Dear Chair LePage and Planning Commissioners:

**II. Demolition of more than 50% of existing walls including the nonconforming east and west walls– does this trigger rebuilding to current code?**

DS 23-221 (Mardani)  
 November 8, 2023  
 Project Data Table  
 Page 1 of 1

1

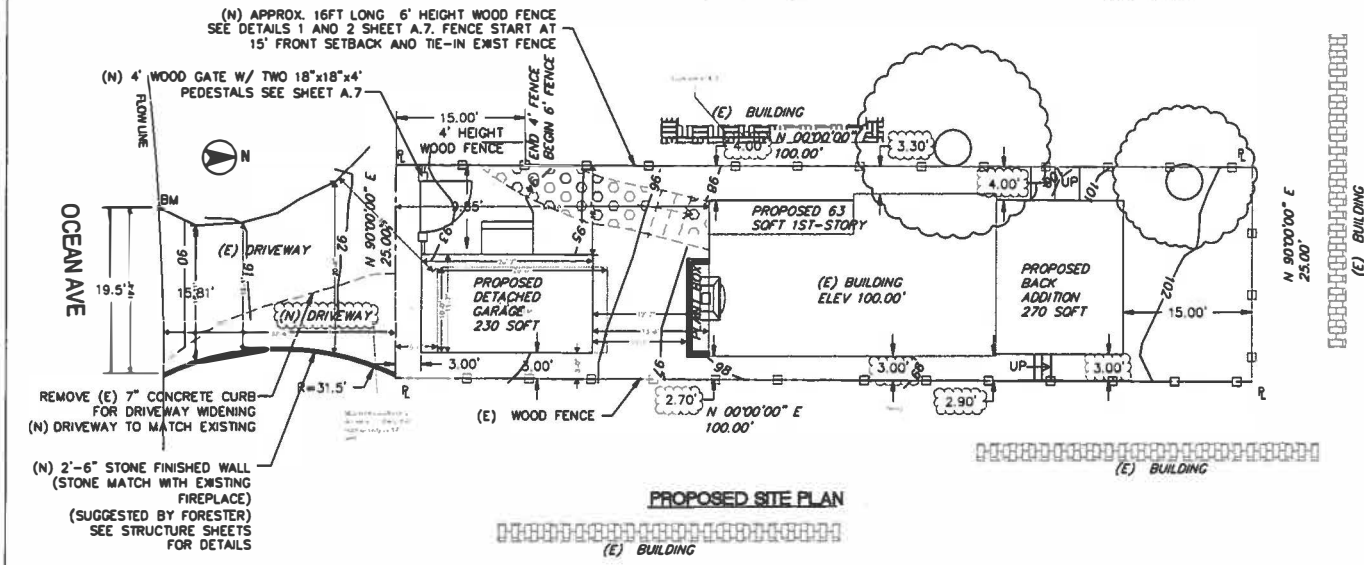
On Sheet 1, illustrating the Existing Site Plan and the Proposed Site Plan (please see Appendix 1), the east setbacks closest to my property are indicated at 2.7' and 2.9' in the Existing Site Plan and seemingly at 3.0' (2.7', 2.9', and 3.0' all appear in a very confusing drawing) in the Proposed Site Plan. This drawing does not make sense in that the existing setback clearly ranges from 2.7' to 2.9'.

**How can the east setback be shown at 3' in the Proposed Site Plan when this is clearly not true?**

3. On page 5 of the plans, also called Sheet 1 and showing the existing and proposed fence lines and tree locations, the Existing and Proposed Site Plans are exactly same (the new garage and new extensions are not shown) and both show incorrect setbacks.
